Kennedy Space Center (KSC) Launch Complex 39 (LC-39) Gaseous Hydrogen (GH_2) Vent Arm Behavior Prediction Model Review Technical Assessment Report

|  | <p align="center">NASA Engineering and Safety Center Technical Assessment Report</p> | <p>Document #: RP-05-114</p> | <p>Version: 1.0</p> |

The NESC Assessment Team reviewed a computer simulation of the LC-39 External Tank (ET) GH₂ Vent Umbilical system developed by United Space Alliance (USA) for the Space Shuttle Program (SSP) and designated KSC Analytical Tool ID 451 (KSC AT-451). The team verified that the vent arm kinematics were correctly modeled, but noted that there were relevant system sensitivities. Also, the structural stiffness used in the math model varied somewhat from the analytic calculations. Results of the NESC assessment were communicated to the model developers.

Figure 7.2-1 Haunch Pivot Arm Slots (HPAS)

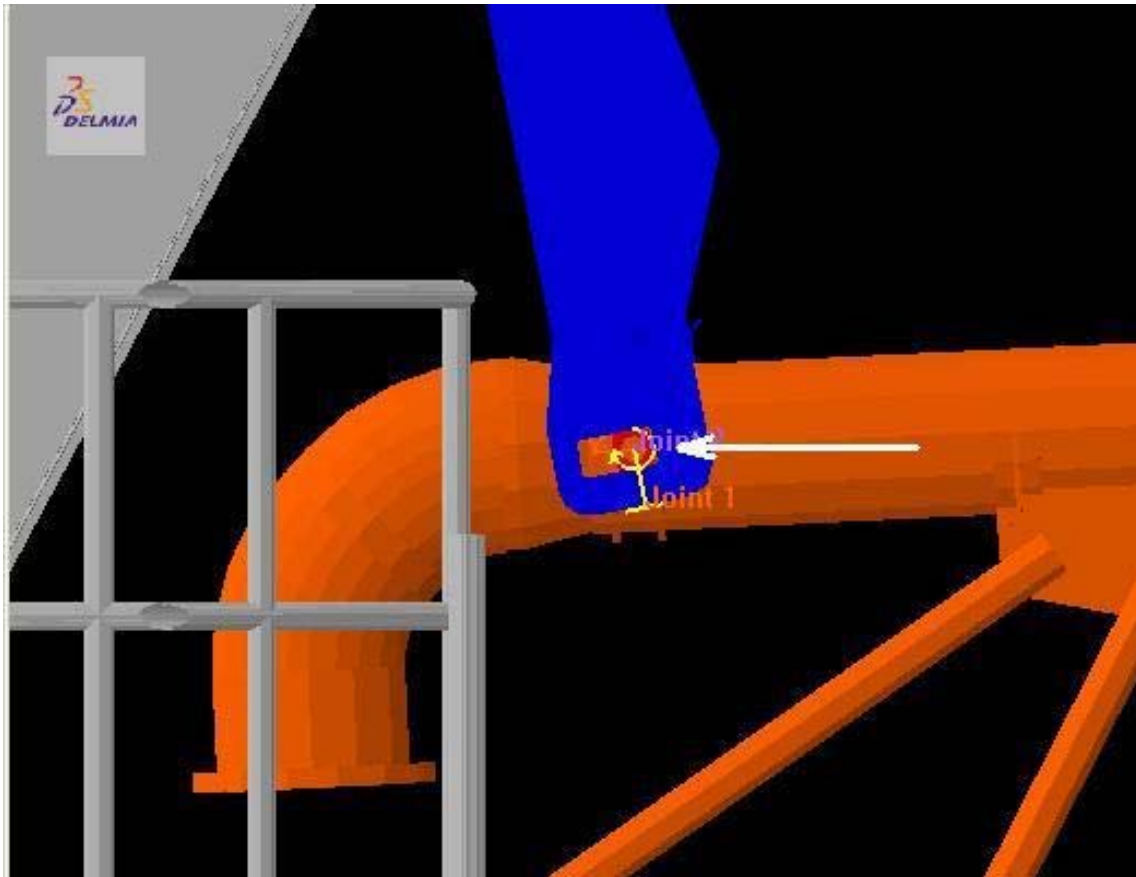
The second centering force occurs when the vent arm is not parallel with slots on the pivot arm. The Haunch Pivot Arm Slots (HPAS) develop contact force between the slider block, which surround the trunnions, as the vent pipe rotates down. The slots in the haunch pivot arm are initially parallel with the vent arm pipe while the GUCP is attached to the ET (refer to Figure 7.2-1). This allows the vent arm to yaw side to side to accommodate the motion of the ET just prior to Solid Rocket Booster (SRB) ignition (“twang”).

The arrow indicates the contact force on the slider blocks from the retraction weights.

Figure 7.2-2. The HPAS at Approximately 40 Degrees to the Vent Arm
Excursions in this position will cause the vent arm to roll and bend the aft flex base.

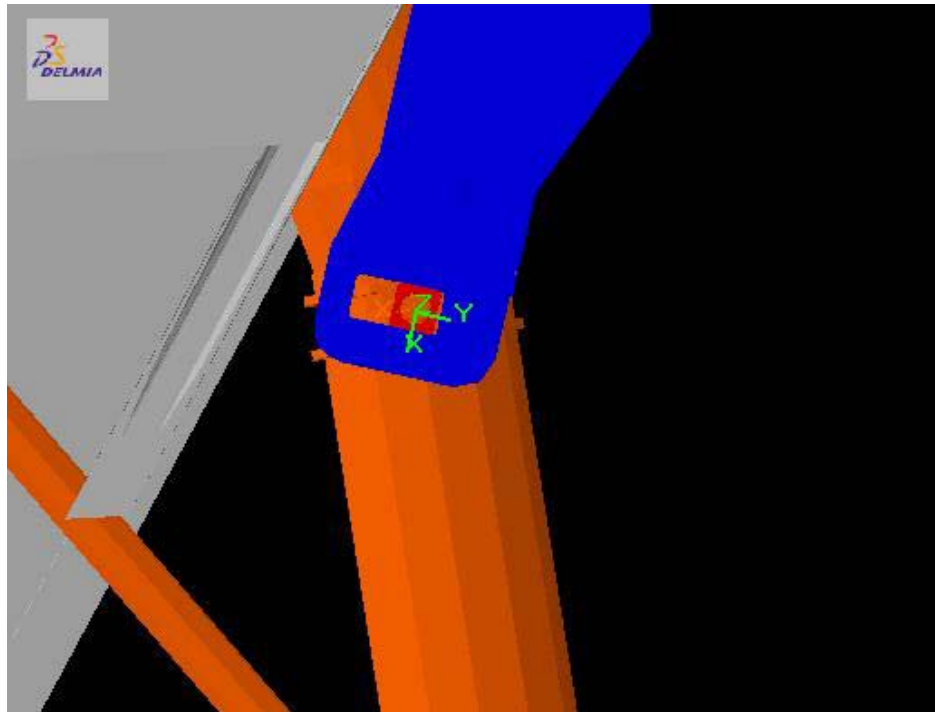
Once the pipe has rotated so that it is no longer parallel with the HPAS (refer to Figure 7.2-2), any clearance between with the HPAS and the slider block is initially bottomed out, and out-of-

plane excursions cause a contact force between the slider block and the top and bottom of the HPAS. This contact force bottoms-out one trunnion and drives the other trunnion up the HPAS, which will lift the retraction weights as in the first scenario. There will also be an associated vent pipe to roll along its axis, which will twist the aft flex line.

It is expected that the contact forces between the HPAS and the slider blocks vary substantially for different operational conditions and could have been very large. If the forces are large enough, the slider blocks, HPAS, and the bushings and/or bearings will be damaged. Periodic inspections and replacement of this hardware should catch visible damage, but tolerances between parts will vary. Wear and tear tolerances were reviewed subsequent to STS-108 and documented in the investigation report; this was not considered a significant factor in the anomaly.

Figure B.1. End of Vent Arm as it Enters Deceleration Unit

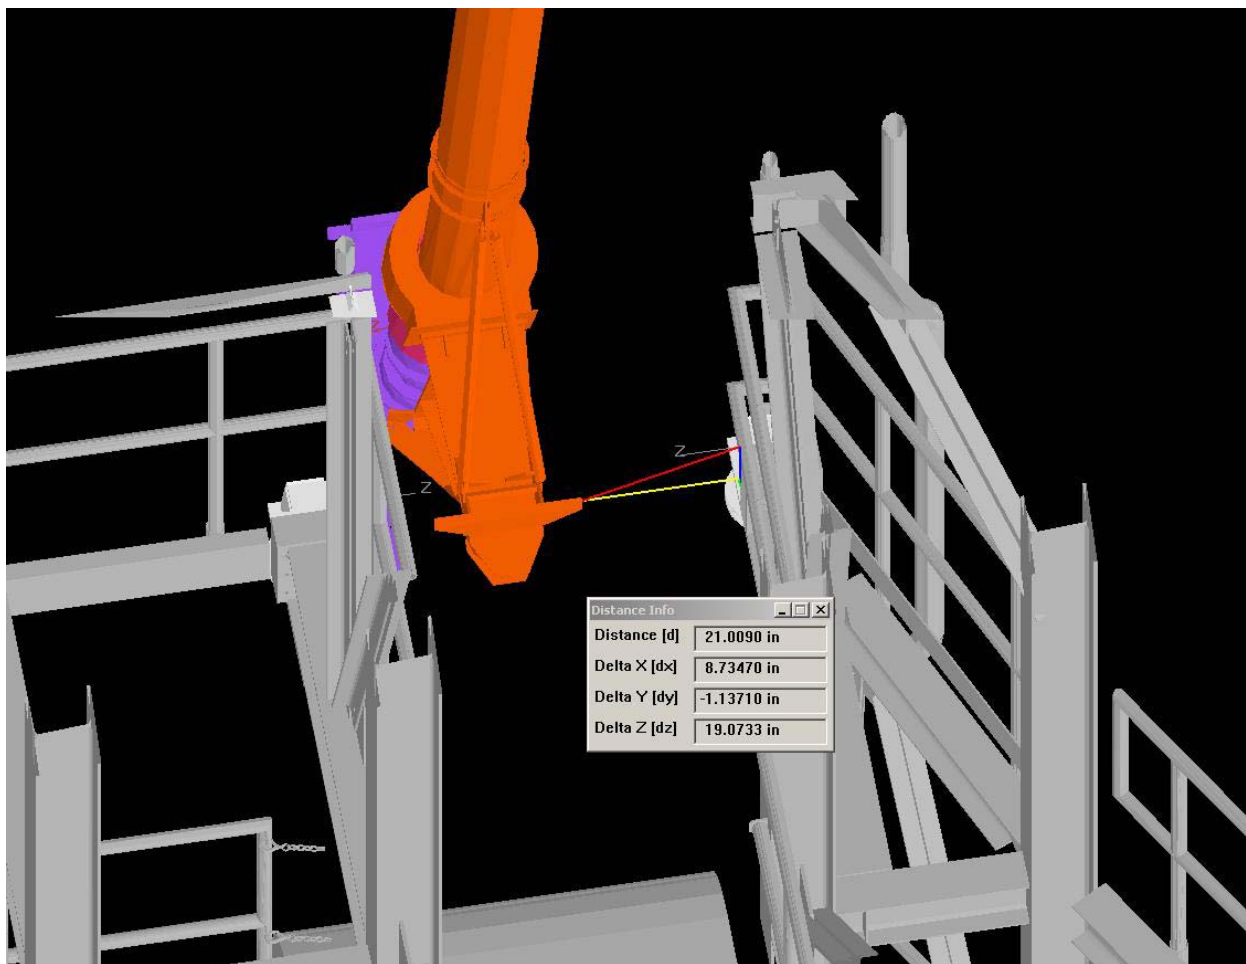
The out-of-plane excursions of the vent pipe, as it enters the deceleration unit, are sensitive to torsional flexure of the pivot arm and to any slope in the pivot arm to slider block joint or the slider block to trunnion joint. These sensitivities are illustrated in Appendix B.

Model contains post STS-108 update to the Structure and a horizontal clearance of 19.07”.

Figure B.2. Pivot Arm Flexure Sensitivity

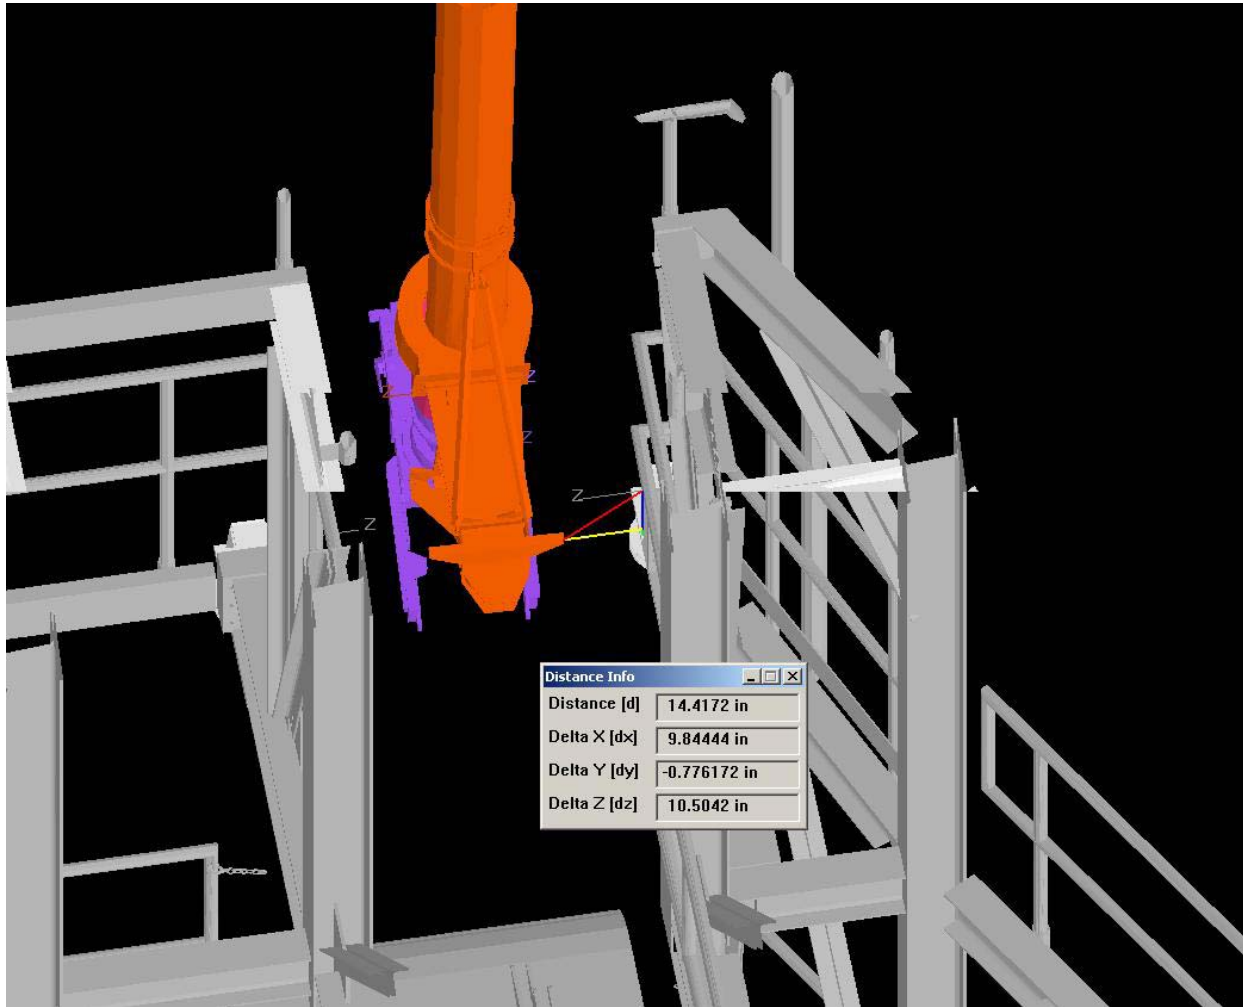
End of vent arm clearance with the Deceleration Unit when the pivot arm is flexed 3 degrees from joint with FSS and joint with Slider Block. Clearance is reduced from 19.07” to 10.5” on the modified Deceleration Unit.

Figure B.3. Joint Stop Sensitivity

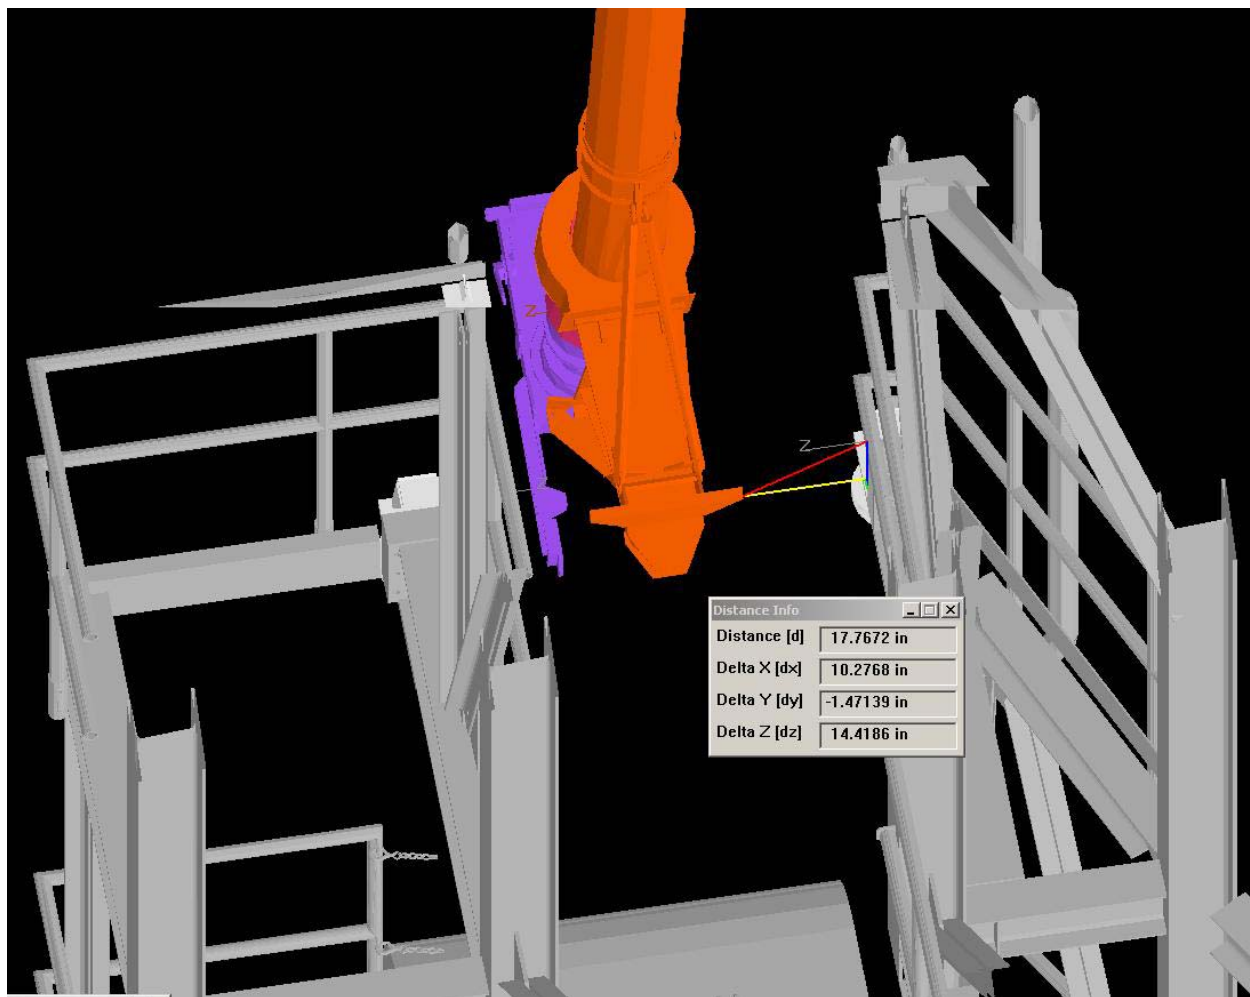
End of arm clearance with the Deceleration Unit when the two joints between the pivot arm and the Slider Block and the Slider Block and the Trunnions have a combined slope equal to one degree. Clearance is reduced from 19.07” to 14.41” on the modified Deceleration Unit.
